Change Order

Radcliff Elementary School Renovation
- Phase 3
1145 S. Dixie Boulevard
Radcliff, Kentucky 40160

CHANGE ORDER NUMBER: 010**DATE:** August 18, 2011**OWNER:** ☒**ARCHITECT:** ☒**CONTRACTOR:** ☒**FIELD:** ☐**TO CONTRACTOR (Name and address):**

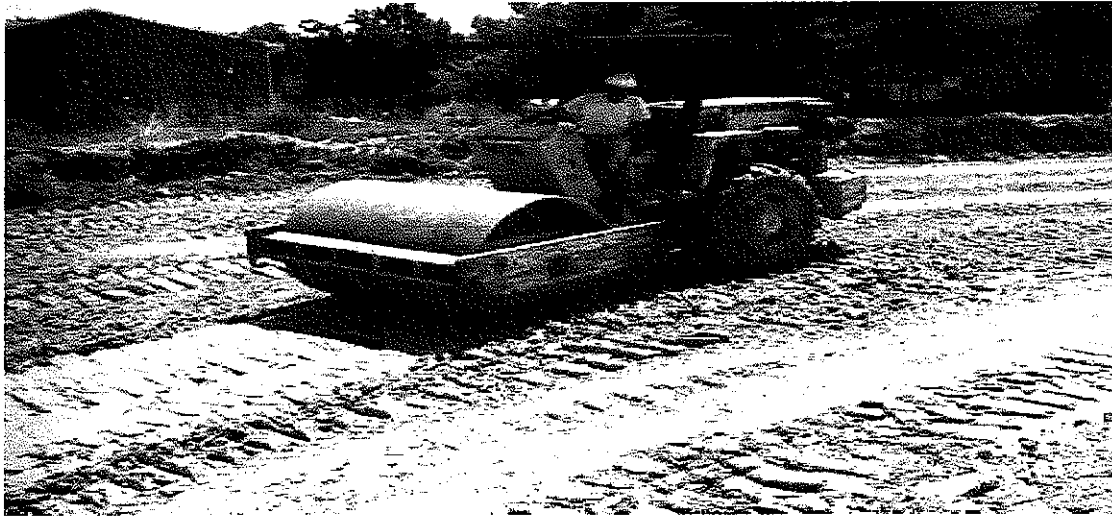
AEI was on site for undercut observation at Radcliff Elementary School. South parking lot on the extreme south quadrant was undercut approximately 30-37" below original elevation. Undercut area ran the entire length of proposed lot and was roughly 34-39' wide. Suitable soil was encountered an average of 2.5' below original grade. All topsoil/ unsuitable material was excavated from site. After all soil had been cleared from undercut, further compaction of sub-grade was obtained by passing over it with a smooth drum roller.

After area was compacted with roller, mesh fabric was placed in the bottom of the excavation. Stone/concrete rubble was then trucked in places as backfill material up to original elevation in about 80 % of area.

*-One area in extreme south east corner was undercut approximately 48" due to large pocket of topsoil encountered.

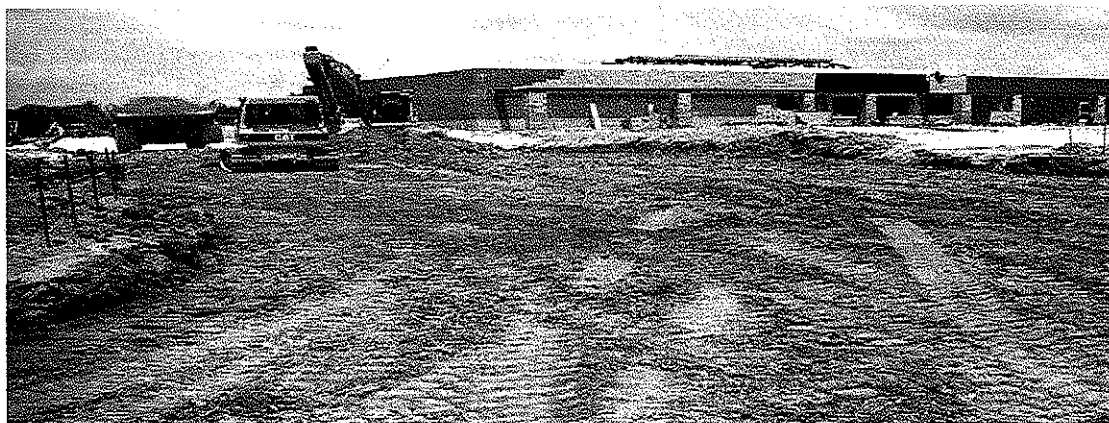
A fully loaded tri-axle dump passed over areas in a random fashion from south access road down to south parking lot and back. Moderate to severe pumping/ rutting was observed in proof-rolled areas. A small test cut was excavated with dozer to find suitable soils at 2' below original elevation. Undercutting of area was recommended and began shortly after evaluation.

Cut area was approximately 37' wide, by 92' long, with an average depth of 24".

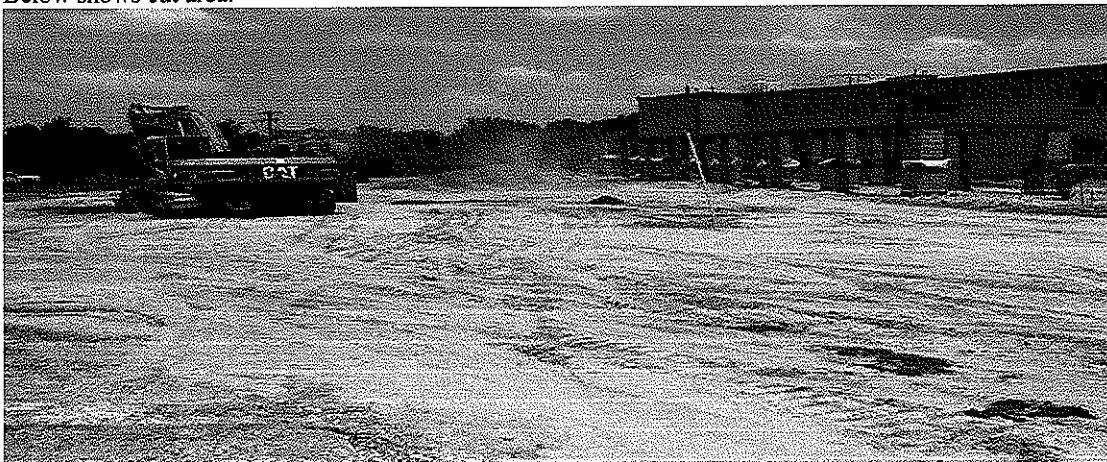
Access road down to bus loop was cut to subgrade and proof- rolled to identify any unsuitable material. A fully loaded rear dump passed over the area in a random fashion and showed acute to moderate pumping/ rutting in areas tested. Undercut was again recommended and began shortly thereafter.

Cut area was approximately: 105' long, an average of 39' wide, and an average depth of 2.0'.

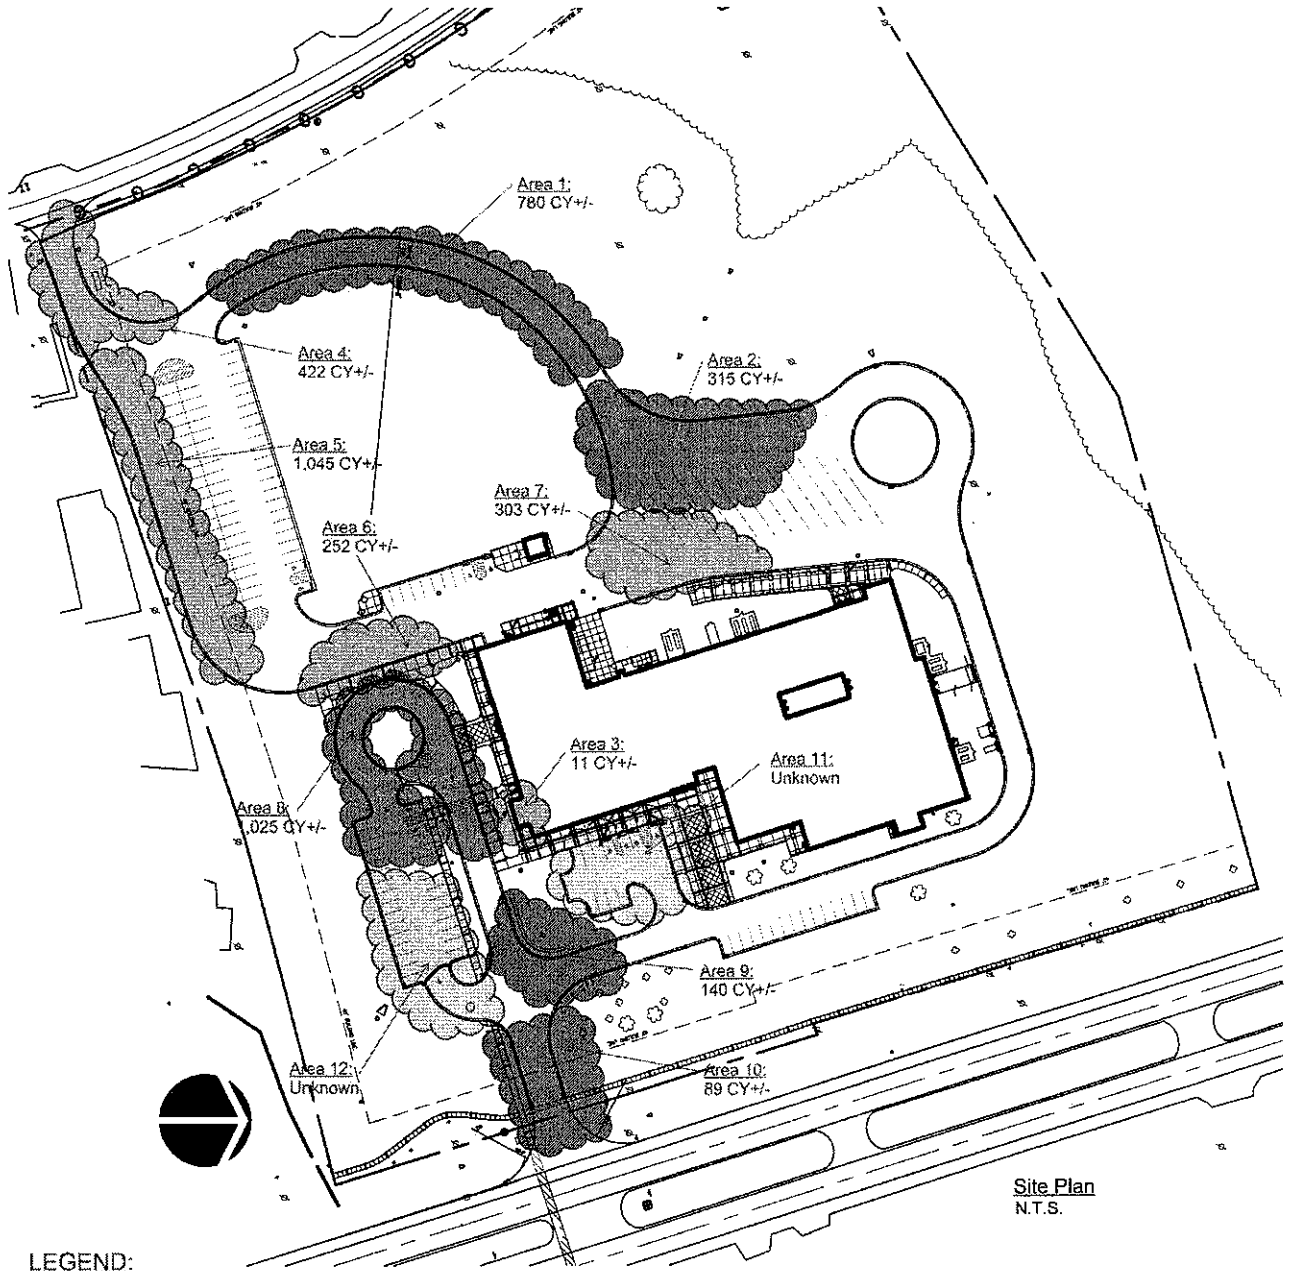
Please refer to the following site plan that indicates all areas of unsuitable soils encountered on site, as well as areas of anticipated unsuitable soils. According to Bischoff, in all areas of cut and fill, approximately 50% of unsuitable soils encountered were wet lean clay material and 50% highly organic soils.

Area 1: (February 2011) - Contains approximately 780 cubic yards that was undercut due to unsuitable soils and replaced with rubble concrete fill material. The site contractor installed geotextile fabric below the fill material. The site contractor, at no additional cost to the Owner, conducted this work in order to stay on the aggressive construction schedule, as well as to have the bus loop usable by buses per the construction phasing schedule.

Area 2: (April 2011) – Contains approximately 315 cubic yards of undercut unsuitable soil material and replaced with rubble concrete fill material. The site contractor installed geotextile fabric below the fill material. The school board approved the additional cost associated with this work, via Change Order No. 4.

Areas 3 through 7: (July 19, 2011) – Contains approximately 2,033 cubic yards of undercut unsuitable soils material and replaced with rubble concrete fill material. The site contractor has agreed to install geotextile fabric below the fill material. The additional cost associated with this work will be submitted to the school board via Change Order No. 10.

Areas 8 through 10: (After July 29, 2011) – Contains approximately 1,254 cubic yards of undercut unsuitable soils material that will be replaced with rubble concrete fill material. The site contractor has agreed to install geotextile fabric below the fill material. The additional cost associated with this work will be submitted to the school board as a future change order request once final quantities have been identified.

Areas 11 and 12: Potential undercutting and fill material may be required in these areas. When site excavation begins in these areas, it will be determined whether unsuitable soils are present. Should the unsuitable soils contain higher clay content, lime stabilization may be considered as method for remediation. The site contractor has also agreed to dig test holes in order to estimate depth of any unsuitable soils prior to site construction in these areas.
